COY PLANNING COMMISSION

- APPLICATION:**
- A. Negative Declaration
 - B. Tentative Map to establish one air space condominium lot.
 - C. Special Permit to develop 120 condominium units on 9.8 vacant acres in the Single Family Alternative (R-1A) zone.

PROPOSAL: The applicant is requesting the necessary entitlements to construct 120 unit condominium project on 9.8 acres.

SITE PLAN

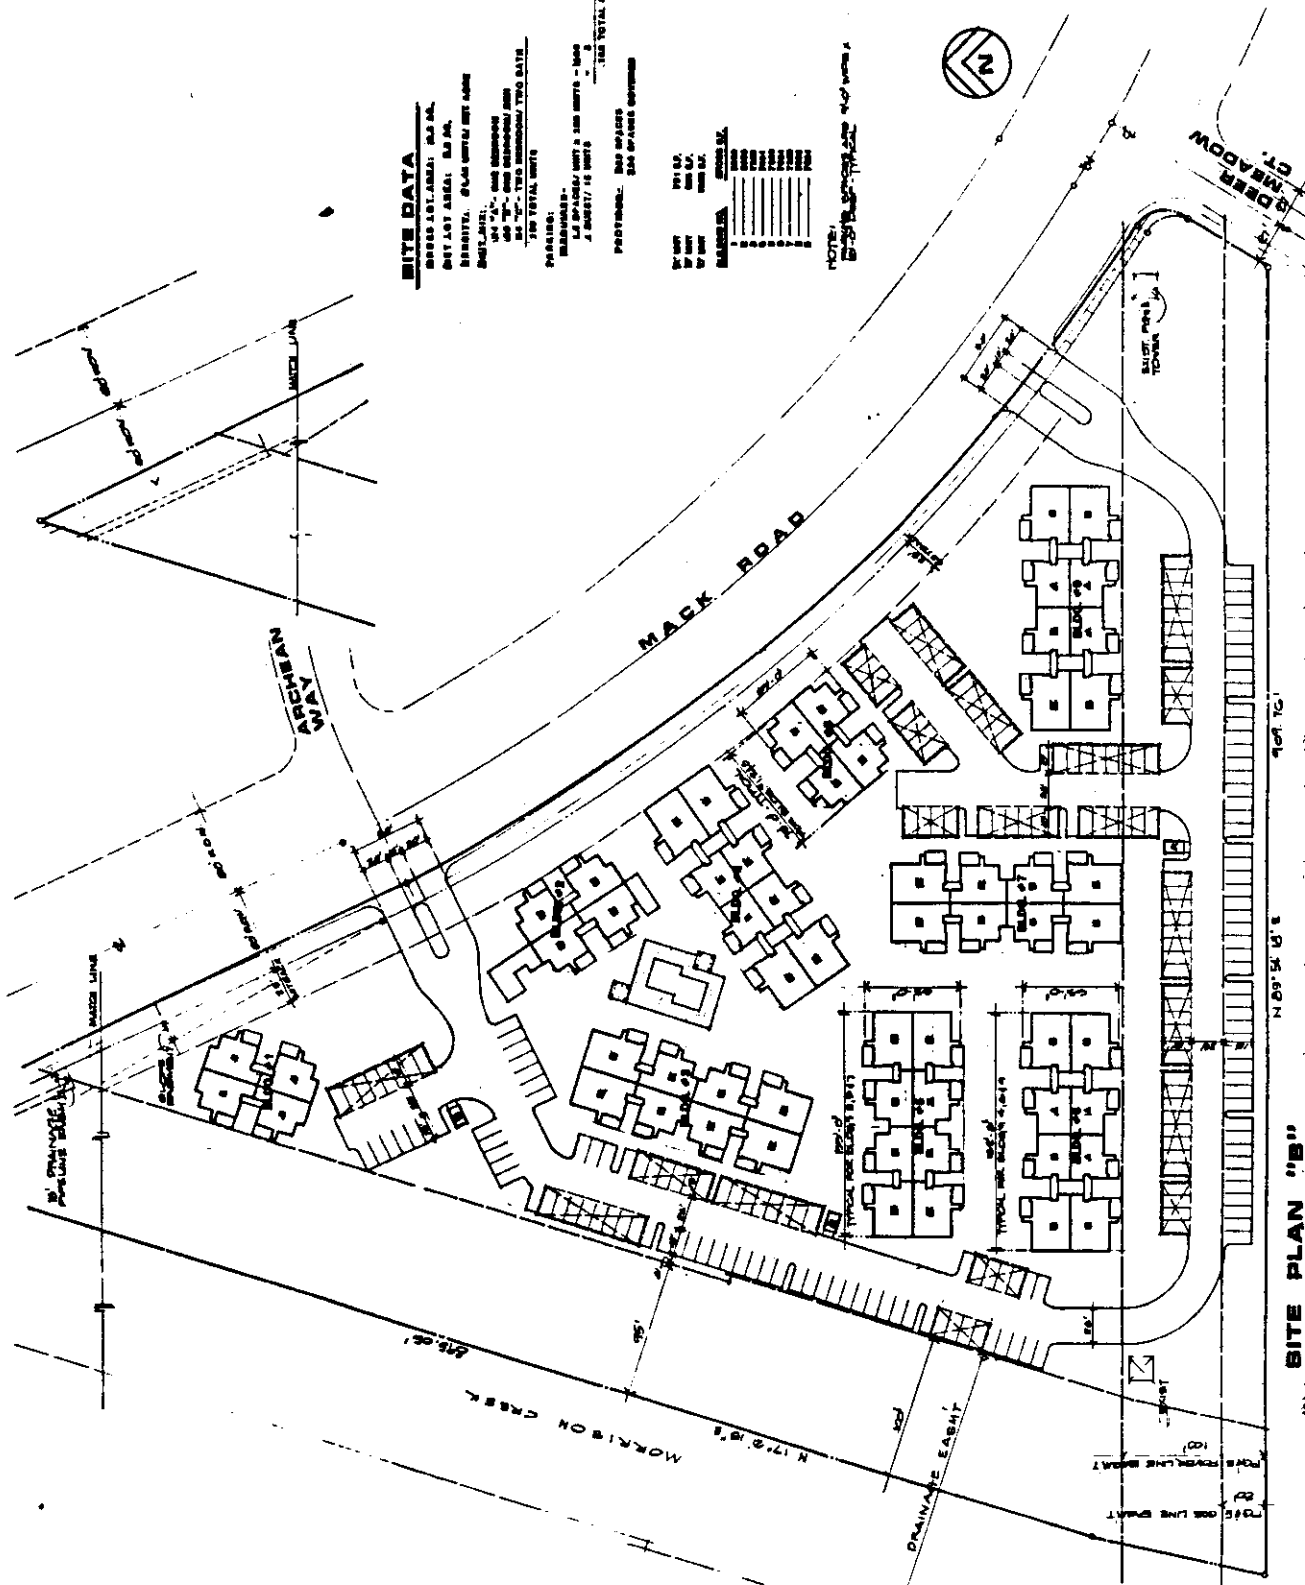
Since the square footage is similar, the project is basically a redesign of the exterior buildings and an increase by 20 units on the site. The applicant proposes 233 parking spaces with 125 covered spaces. Figures provided on the site plan are incorrect. A revised site plan shall show all parking spaces numbered, for verification.

- D. No bicycle parking is shown on the site plan. Staff recommends that the applicant provide one bicycle parking facility for every 10 parking spaces as required by the Zoning Ordinance. A revised site plan indicating the bicycle parking areas shall be submitted for review and approval prior to issuance of building permits.

- F. Other site amenities include a pool and pond (pool and pond not shown on site plan). A common storage area is also indicated for homeowner's use. The applicant should also provide a clubhouse adjacent to the pool area. The clubhouse design shall be compatible with residential structures and shall be reviewed and approved by staff. The former site plan showed a tennis court. Staff recommends the applicant include a tennis or handball court.

The staff modified site plan proposes changes to the project to enhance the owner-occupants. Building four should be reduced by eight units in order to allow centrally located area for a recreational meeting room, swimming pool and pond. Barbecue, jacuzzi and other amenities could be provided in the central common area. No laundry facility is to be provided for residences.

A six foot high decorative wrought iron fence should be installed along the 25 foot wide landscape setback between the two entryways to prevent residents from parking on Mack Road and crossing the landscaping to their unit.

1. The applicant shall comply with the Multi-Family Residential Design Guidelines. Exhibit A including revisions shown on the staff modified site plan and stated in Section G.

4. Trash enclosures shall be provided in sufficient number and in a convenient location. Additional trash enclosures shall be located on site and a revised site plan shall indicate the additional enclosures.

FLOOR PLAN

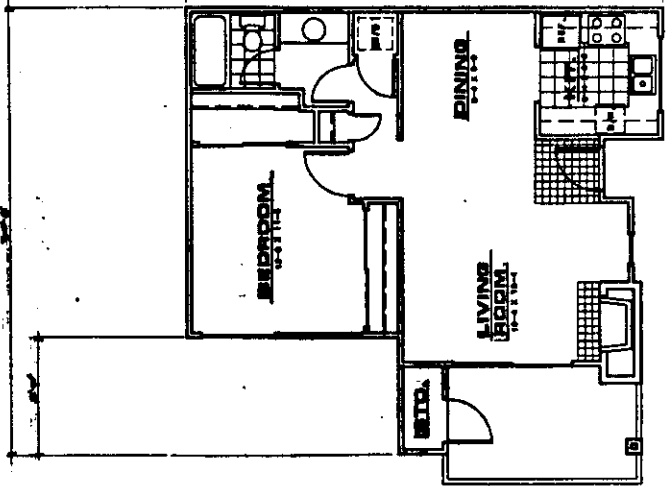
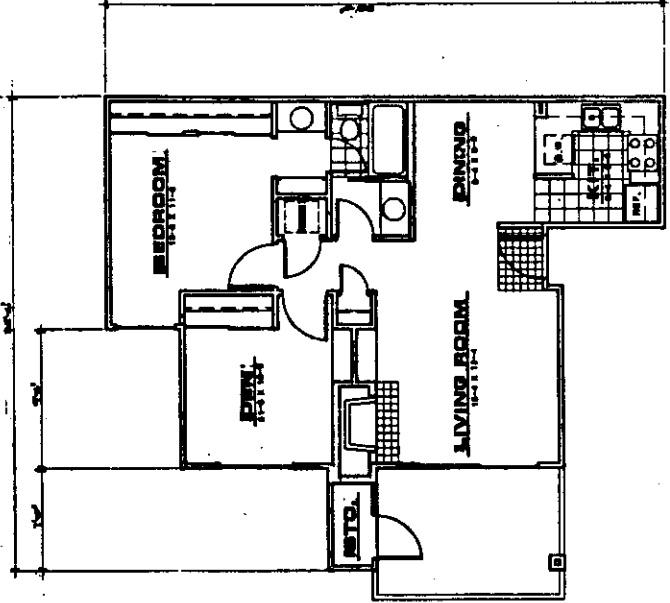
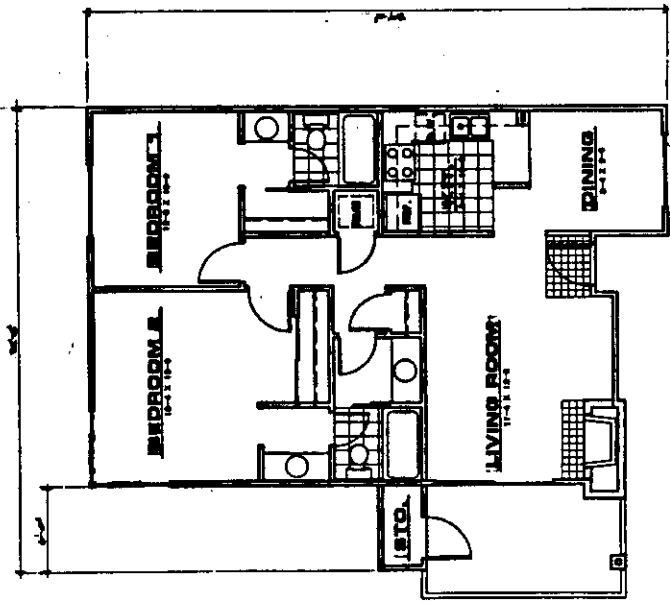
1. Each unit should have one enclosed parking space in a garage.
2. Washing and dryer hook ups are to be provided in each unit.
3. Each unit shall have an enclosable space for storage.
4. An area is to be designated for outdoor vehicle storage for residents.
5. Since the project contains 120 units, a centrally located recreation building with space for association meetings shall be included.
6. At least 50 percent or 60 units should be either two or three bedroom units.

ELEVATIONS

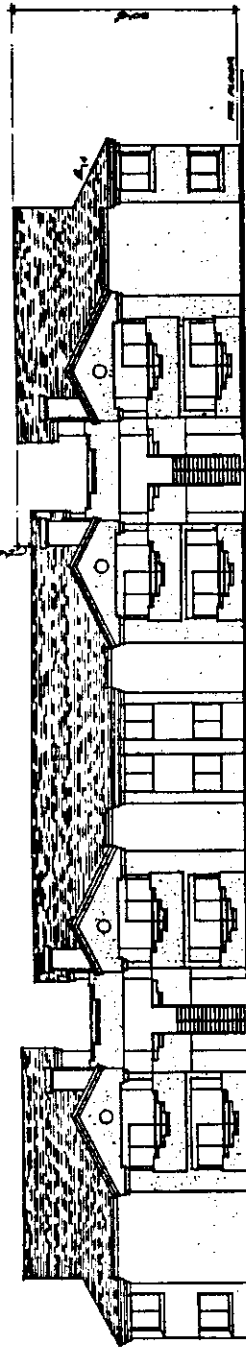
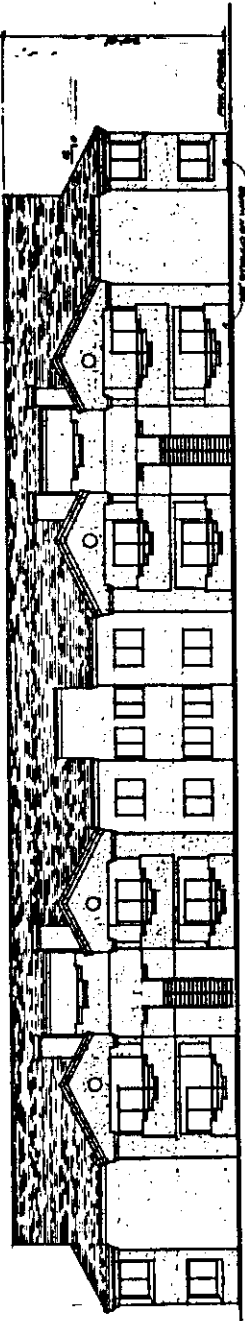
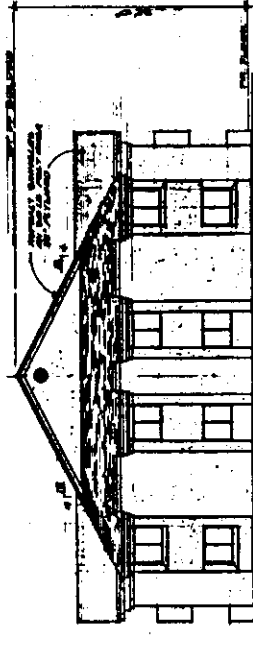
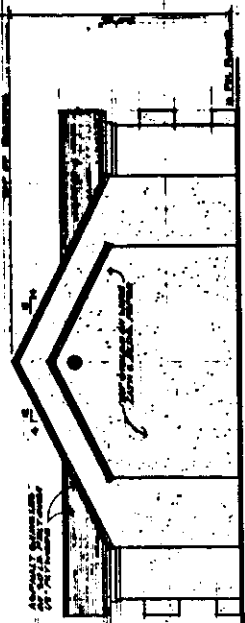
- C. The exterior building materials for the units will include stucco/wood siding and composition shingle roofs. Staff feels that the building design provides good architectural relief on both the front and end elevations for the A and C units. The B unit end elevations shall be revised to show more relief.

7. The buildings shall include the following items:
 - a. Exterior materials shall include wood and stucco siding with windows or variation on all exterior end elevations of the units.
 - b. Stairs shall have double stringers.
 - c. All roofs shall be covered with wood shake, shingle, tile material or heavy butt composition shingle that is approved by the Planning Director.
8. The applicant shall provide a swimming pool, a clubhouse facility and tennis or handball courts. Design of facilities shall be reviewed and approved by the Planning Director. No common laundry area shall be shown.
9. Roof lines on buildings 3, 5 and 7 shall be broken up and not a continuous line.
